SUBJECT: RIVER BEND STATION, UNIT 1 - AMENDMENT NO. 17 TO FACILITY
OPERATING LICENSE NO. NPF-47 (TAC NO. 65728)

RIVER BEND STATION, UNIT 1

Amendment No. 17
License No. NPF-47

SAFETY EVALUATION BY THE OFFICE OF NUCLEAR REACTOR REGULATION

FIGURE 6.2.1-1
RIVER BEND STATION ORGANIZATION

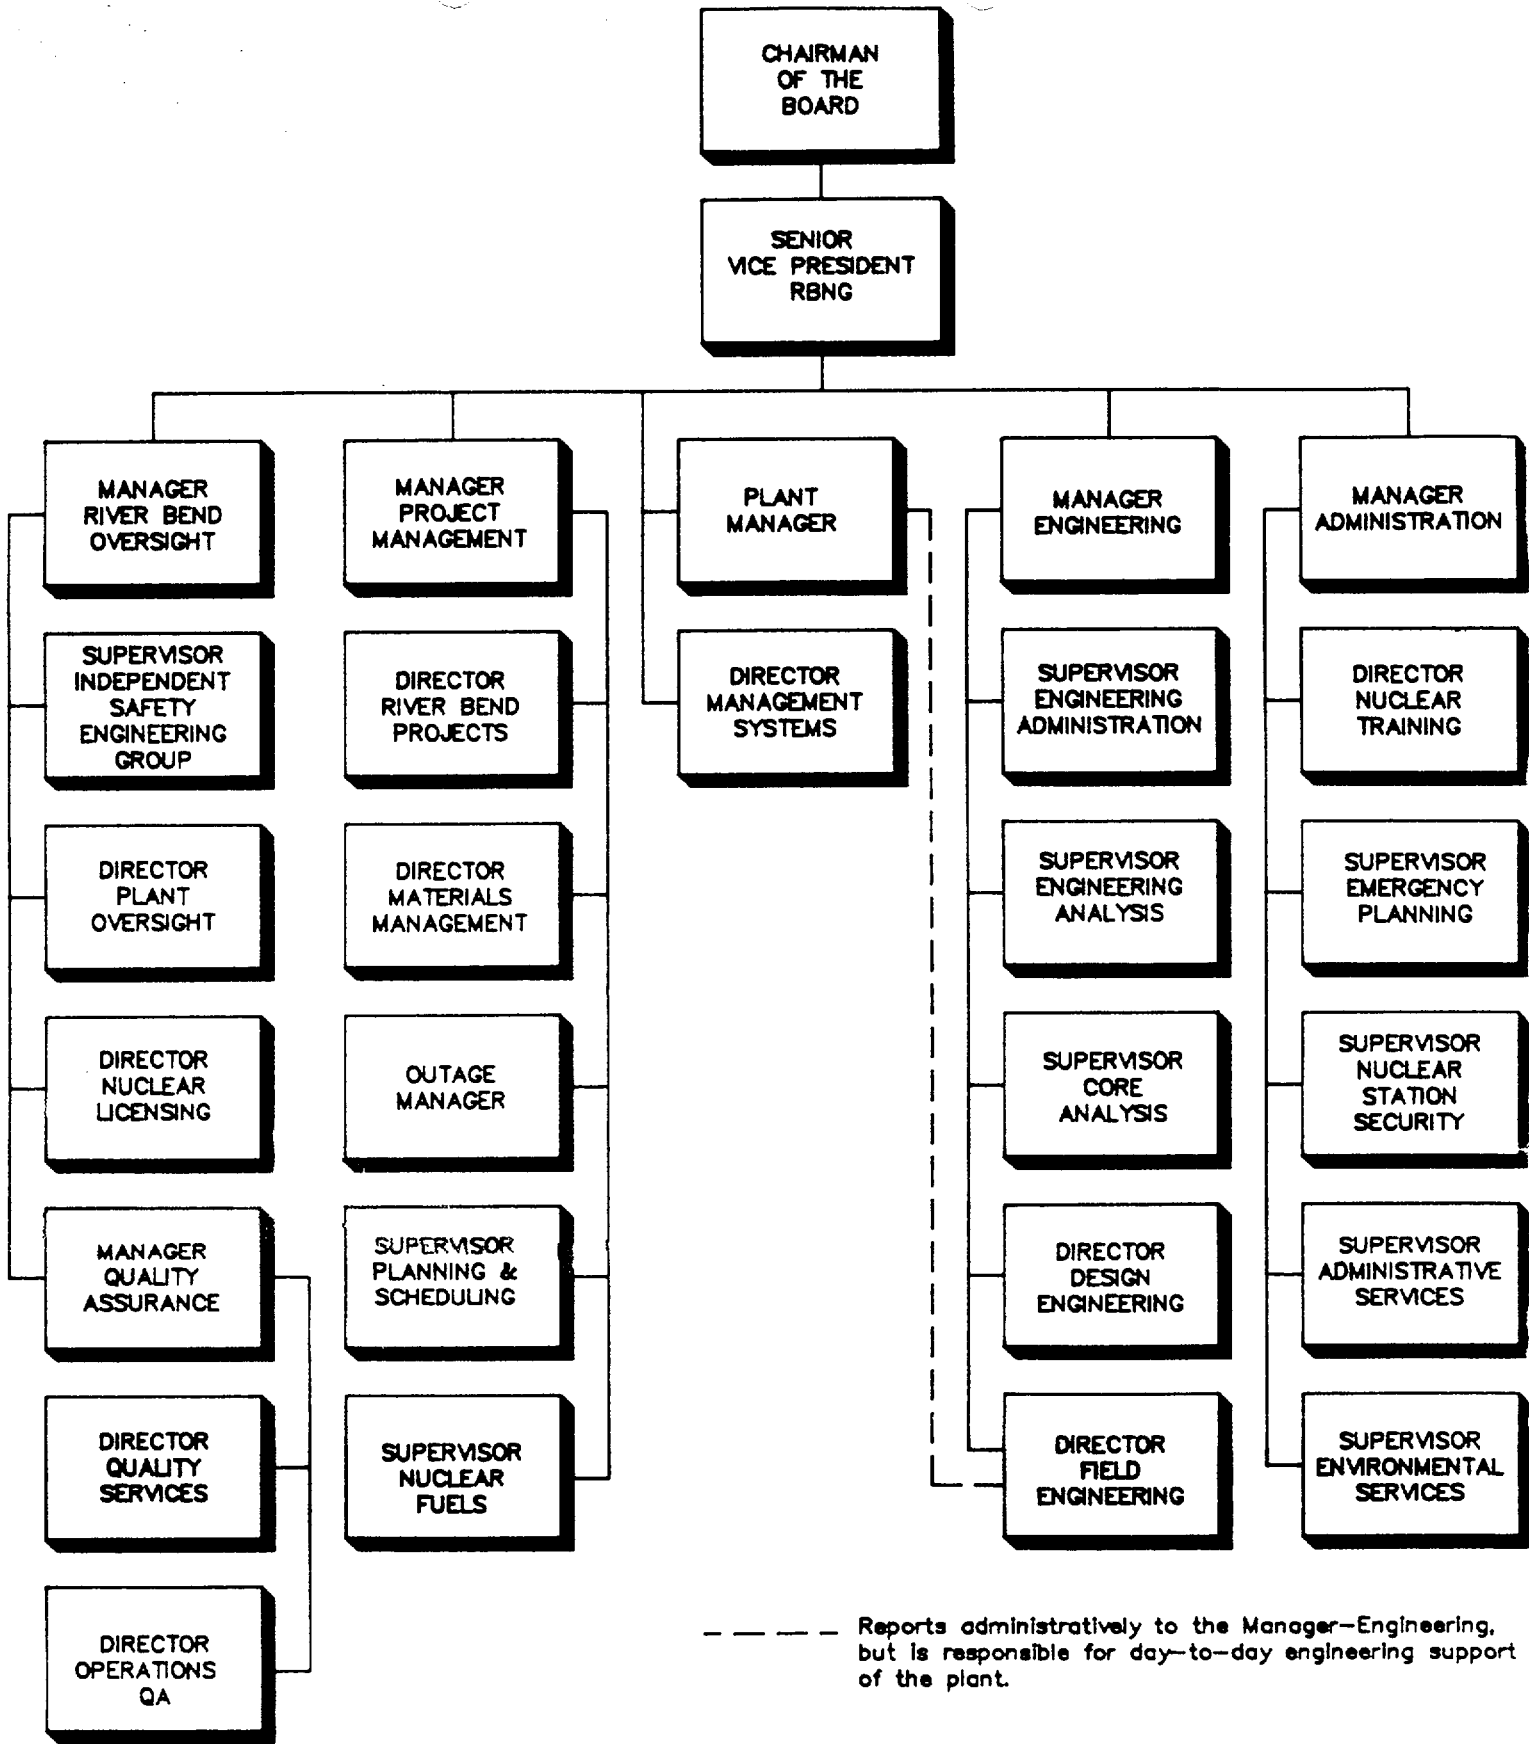
The licensee has revised the offsite organization responsible for supporting the operation of the River Bend Station, Unit 1. The positions of Vice President Safety and Environment, Vice President River Bend Nuclear Group, Manager-Project Control, Manager-Engineering, Nuclear Fuels and Licensing, Director-Nuclear Fuels Design and Safety Analysis, Director-Nuclear Plant Engineering, and Director-Nuclear

Procurement and Contracts have been deleted. The positions of Manager-River Bend Oversight, Manager-Engineering, Director-Design Engineering, Supervisor-Planning and Scheduling, Supervisor-Nuclear Fuels, Supervisor-Engineering Analysis, and Director-Materials Management have been added.

The titles of Manager-Project Planning has been changed to Manager-Project Management, Supervisor Administrative Support has been changed to Supervisor Support Services, Plant Security Supervisor has been changed to Supervisor-Nuclear Station Security, and Supervisor-In-Core Fuels has been changed to Supervisor-Core Analysis. Additionally, several functions have been reassigned within the revised organization.

These changes are shown in revised Figure 6.2.1-1.

The staff finds these requested changes acceptable as they meet the acceptance criteria of Section 13.1.1 of NUREG-0800, Standard Review Plan for the Review of Safety Analysis Reports for Nuclear Power Plant, (the Standard Review Plan).
